Access Compliance Report Public Rights-of-Way (Curb Ramps)

Main Street: ARBOLADA_WAY		Cross Street: PROSPECT_AVE		Location:	SE
ADA ID: RPRK211011123906	Ramp Type:Type 1 - Perpendicular Diagonal		Initial Pass/Fail: Fail	Overall Compliance: No	Severity Score: 30
Codes/Mitigation Info/Possible Solution			Field Measurements/Component Compliance

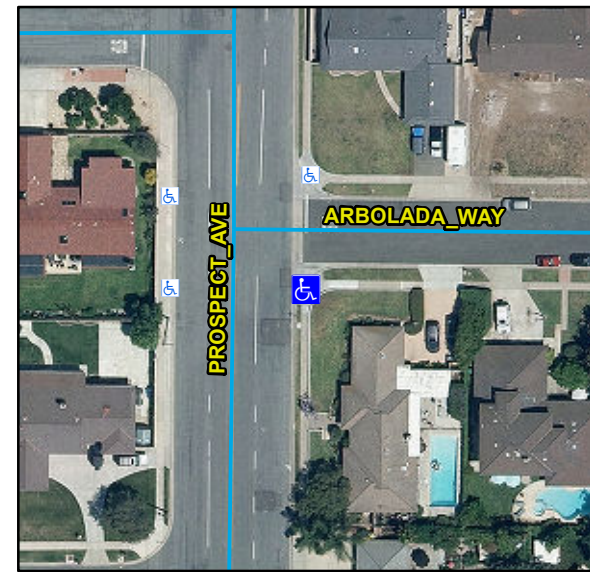
R204.3, R304.2.2, STD 1115

Remove & Replace Curb Ramp With Two New Directional Ramps or Equivalent.
